APPROVED DRAWINGS HAVE BEEN RED LINED INDICATING A CHANGE TO MEET THE OBC. PLEASE REVIEW ALL PAGES TO ENSURE YOU ARE PROPERLY INFORMED OF CHANGES.

TOWNSHIP OF NORTH DUMFRIES BUILDING DEPARTMENT

These Plans have been examined for Compliance with the Ontario Building Code requirements. A Building Permit has been Issued, subject to any changes noted, under the condition that the building will be constructed in accordance with the code.

project
Legacy

FRONT ELEVATION 'A'

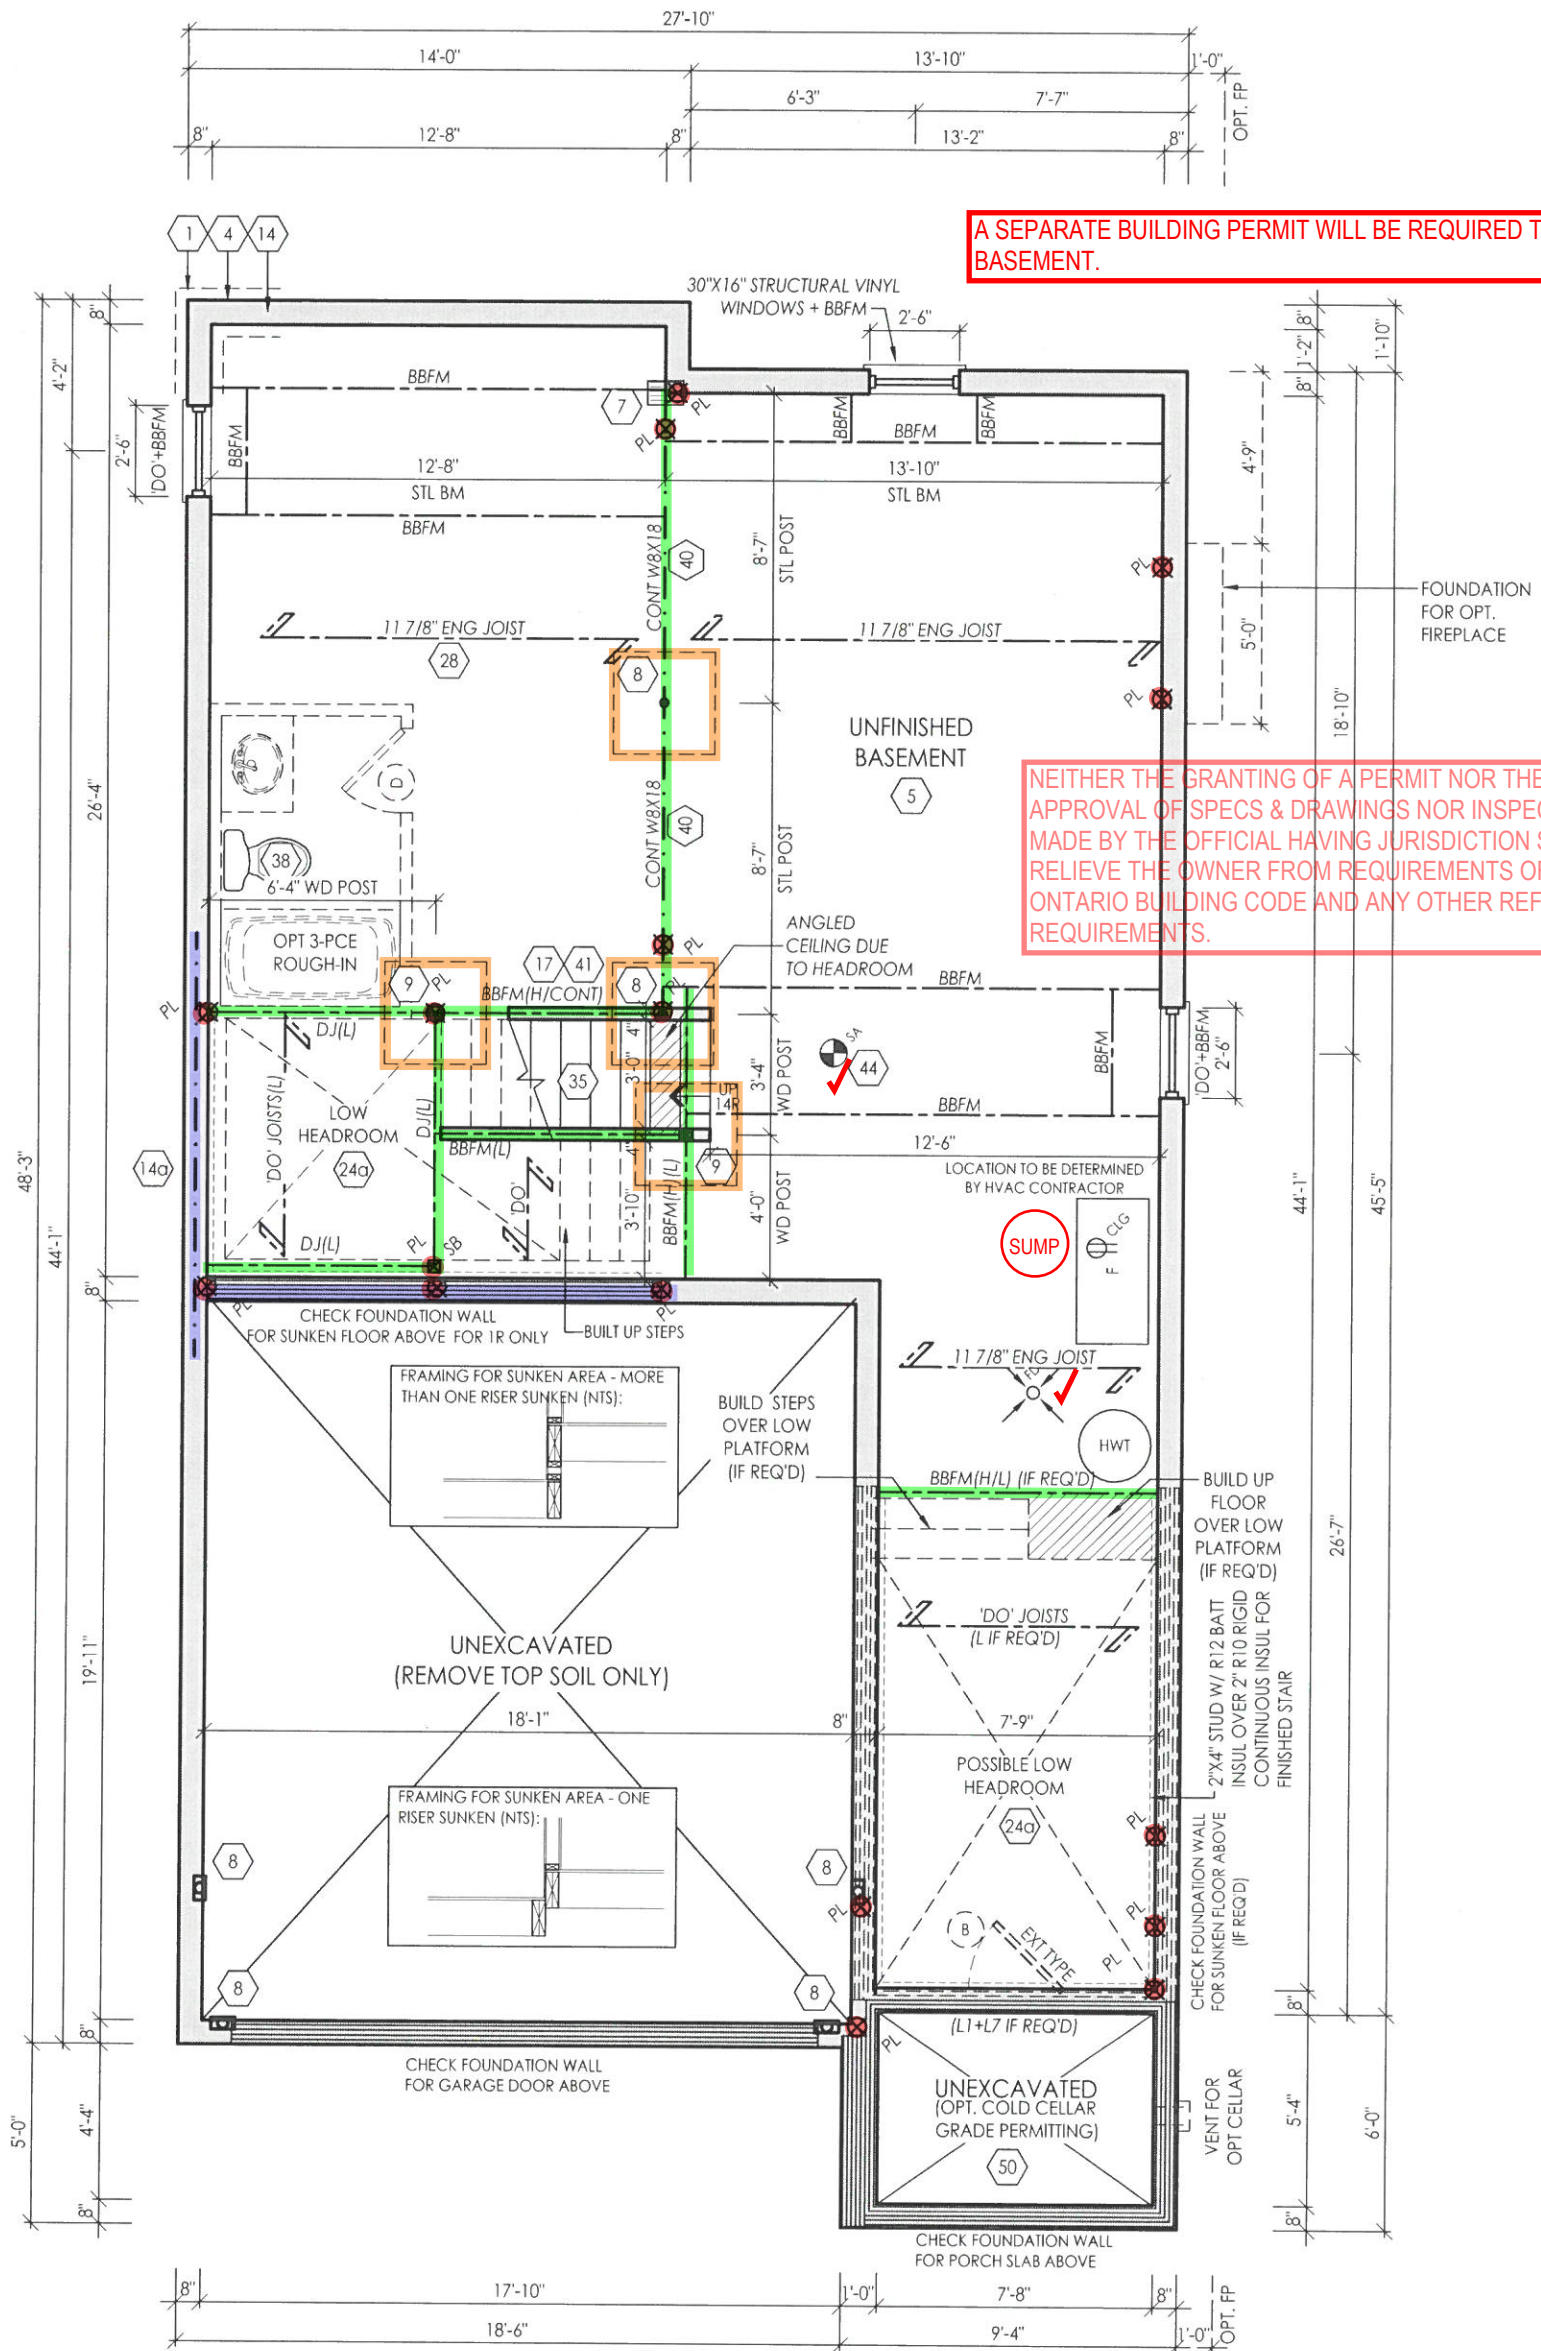
FINAL GRADING CERTIFICATE REQUIRED BEFORE FINAL INSPECTION SIGN-OFF

CALL FOR INSPECTION OF EXCAVATION CRIBBING BEFORE POURING ANY CONCRETE

SECOND FLOOR ELEV. 'B'

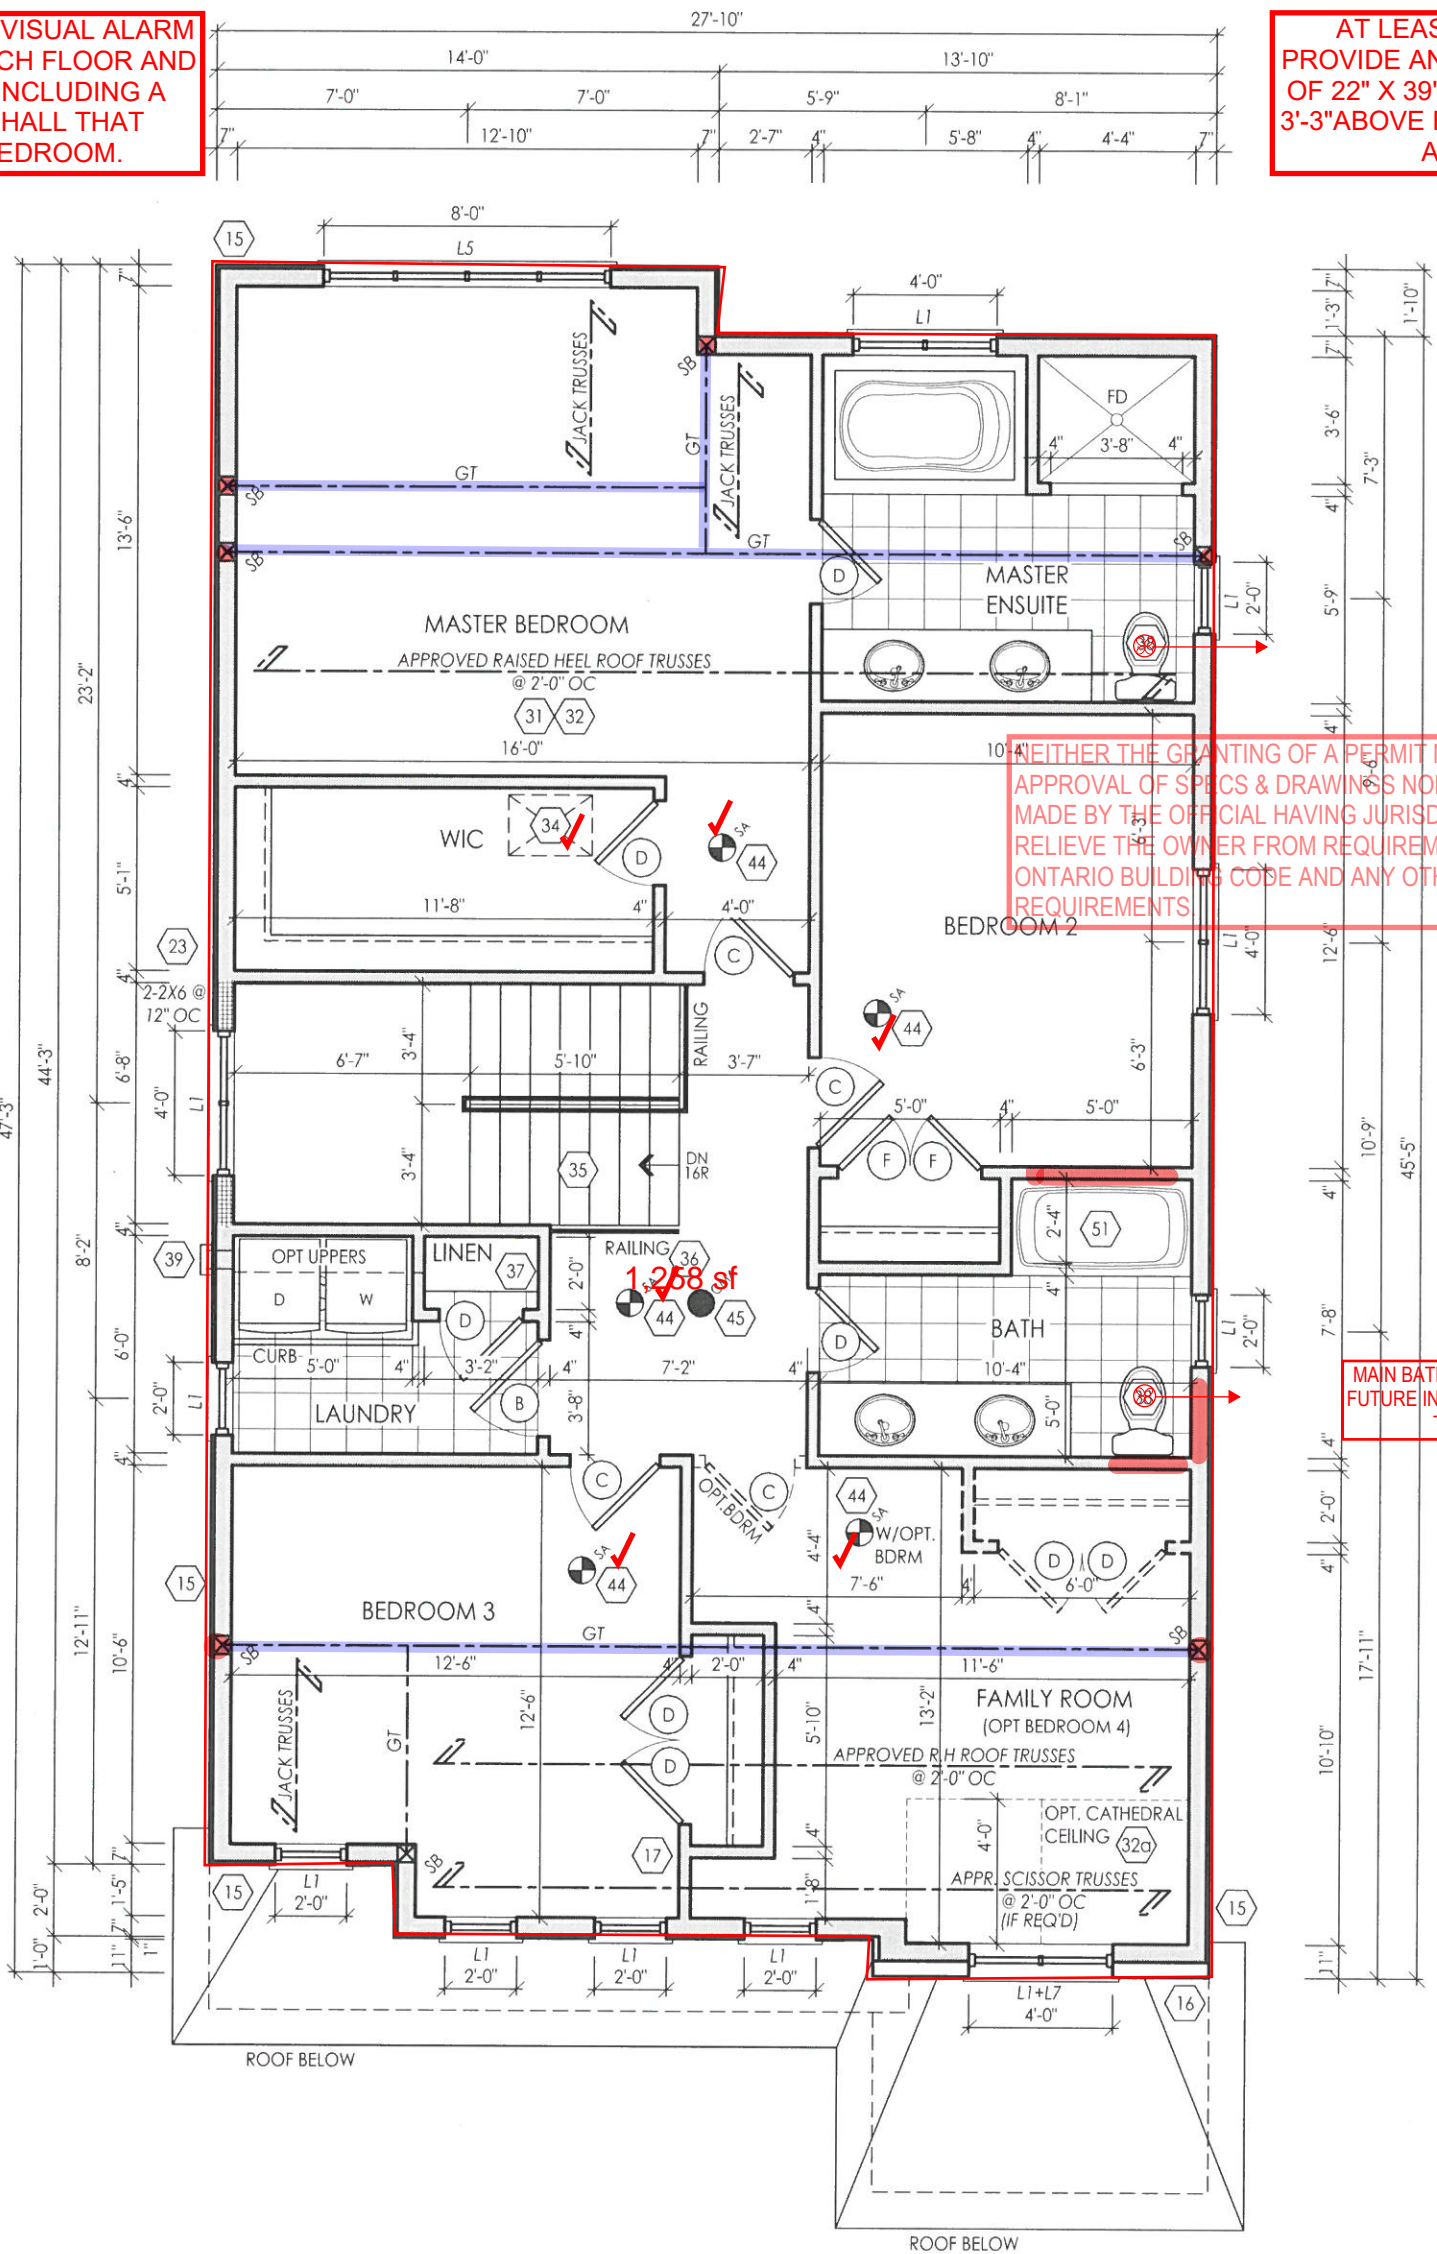
SMOKE ALARMS WITH VISUAL ALARM ARE REQUIRED ON EACH FLOOR AND IN EACH BEDROOM INCLUDING A SMOKE/CO IN THE HALL THAT SERVICES THE BEDROOM.

AT LEAST 1 WINDOW SHALL PROVIDE AN UNOBSTRUCTED AREA OF 22" X 39" W/ A SILL HEIGHT MAX. 3'-3" ABOVE FINISHED FLOOR & 23'-0" ABOVE GRADE

TALL WALL REQUIREMENTS
 (A) THE STUDS ARE CLAD WITH NOT LESS THAN 9.5 MM THICK PLYWOOD, OSB OR WAFERBOARD SHEATHING ON THE EXTERIOR FACE, AND NOT LESS THAN 12.5 MM GYPSUM BOARD ON THE INTERIOR FACE,
 (B) SOLID BRIDGING IS PROVIDED AT NOT MORE THAN 1.2 M O.C.,
 (C) THE STUDS ARE FASTENED TO THE TOP AND BOTTOM PLATES WITH NO FEWER THAN THREE 82 MM TOE-NAILS,
 (D) THE DOUBLE TOP PLATES ARE FASTENED TOGETHER WITH NOT LESS THAN 76 MM NAILS SPACED NOT MORE THAN 200 MM O.C.,
 (E) ROOF FRAMING MEMBERS SPACED NOT MORE THAN 610 MM ARE FASTENED TO THE TOP PLATES WITH NO FEWER THAN FOUR 82 MM TOE-NAILS, AND
 (F) THE BOTTOM PLATE IS FASTENED TO THE FLOOR JOISTS, BLOCKING OR RIM JOIST WITH NOT LESS THAN 82 MM NAILS SPACED NOT MORE THAN 200 MM O.C.

MAIN BATHROOM TO HAVE STUD BLOCKING FOR FUTURE INSTALLATION OF GRAB BARS ADJACENT TO SHOWER/TUB AND TOILET.

REAR ELEVATION 'A' & 'B'

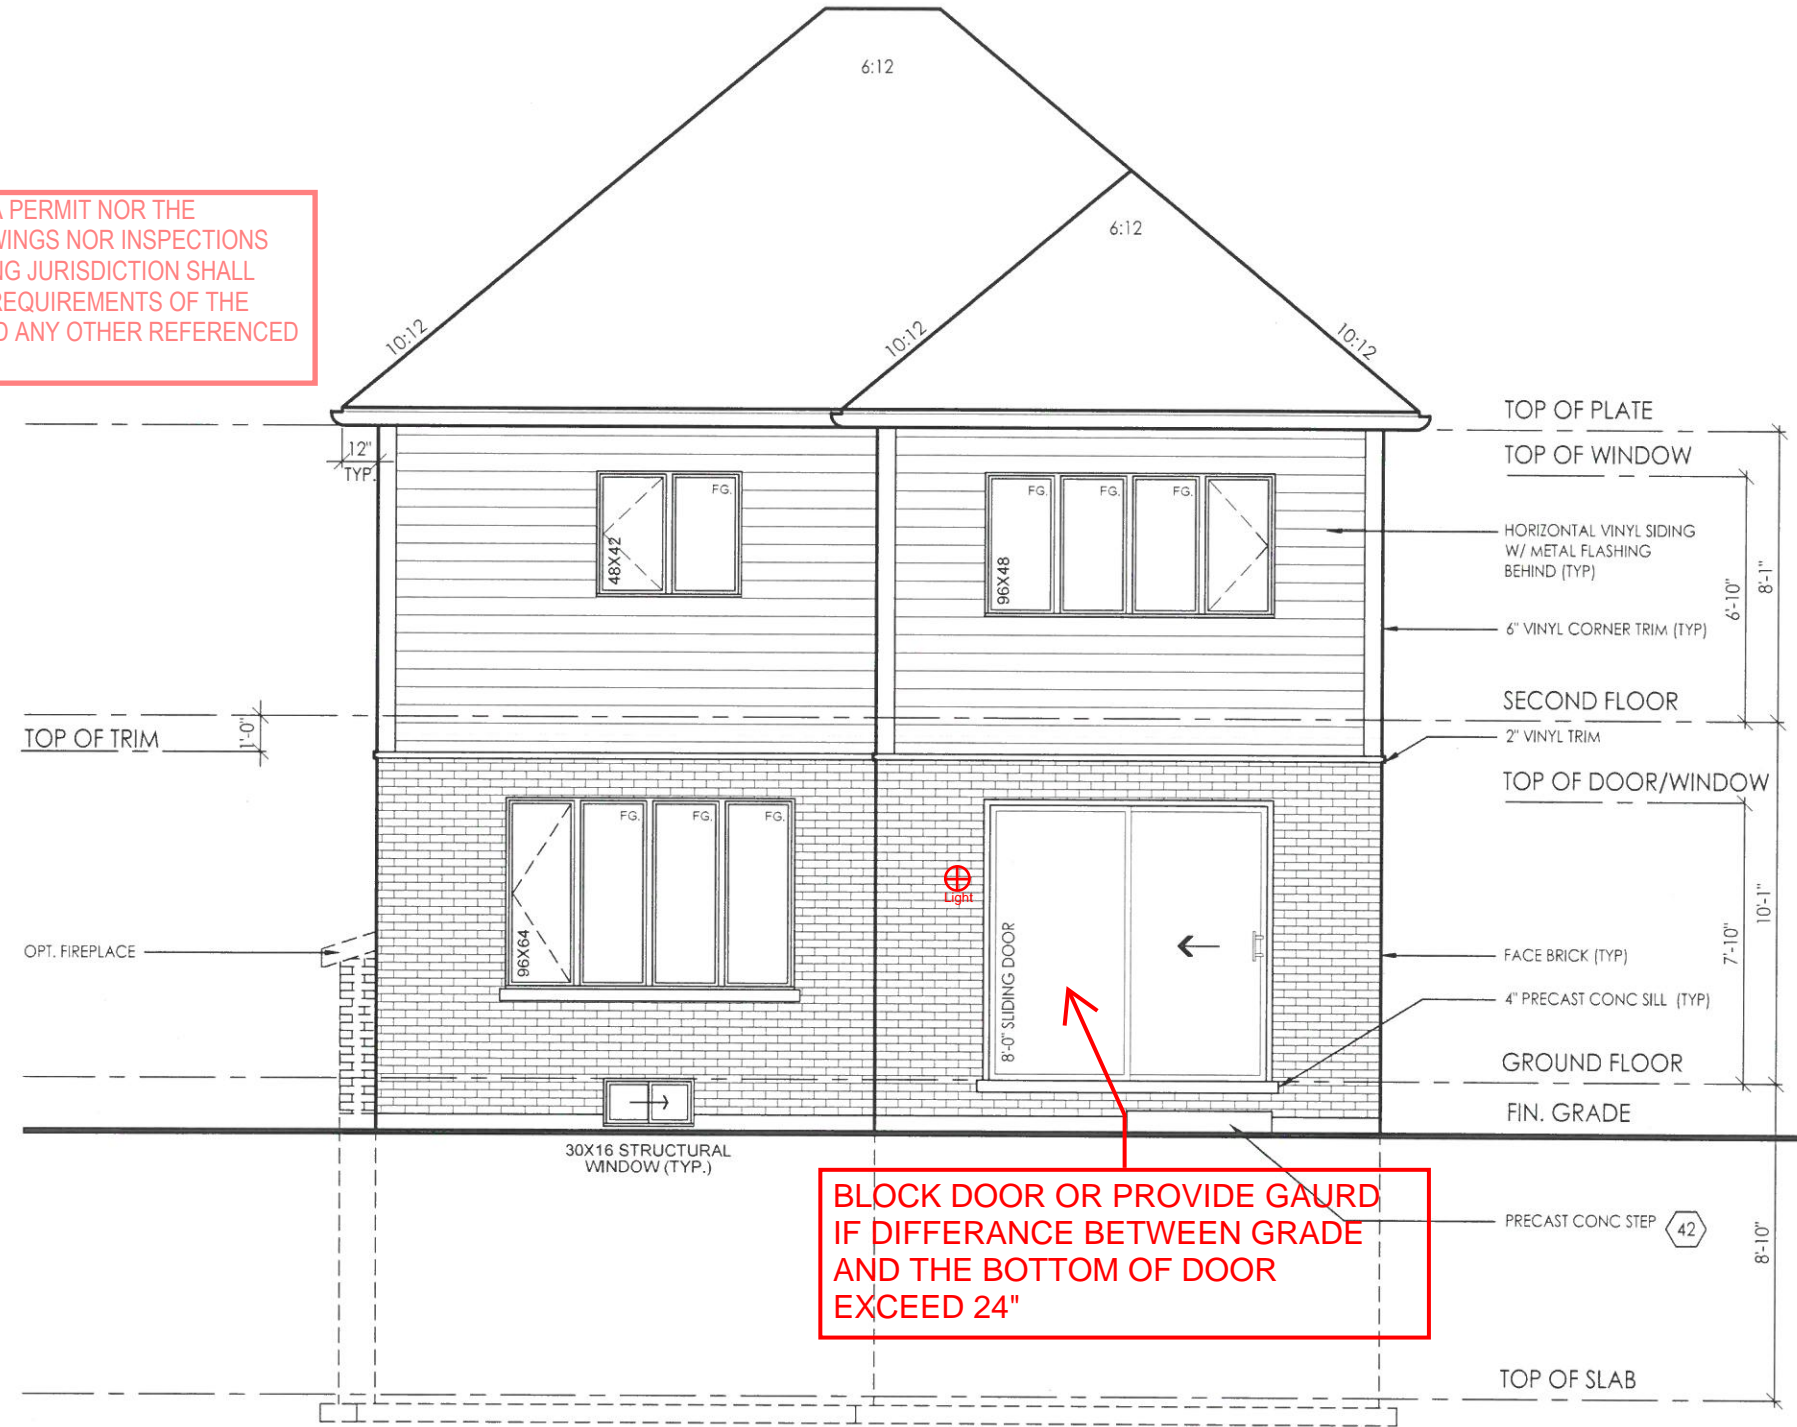
BLOCK DOOR OR PROVIDE GAURD IF DIFFERANCE BETWEEN GRADE AND THE BOTTOM OF DOOR EXCEED 24"
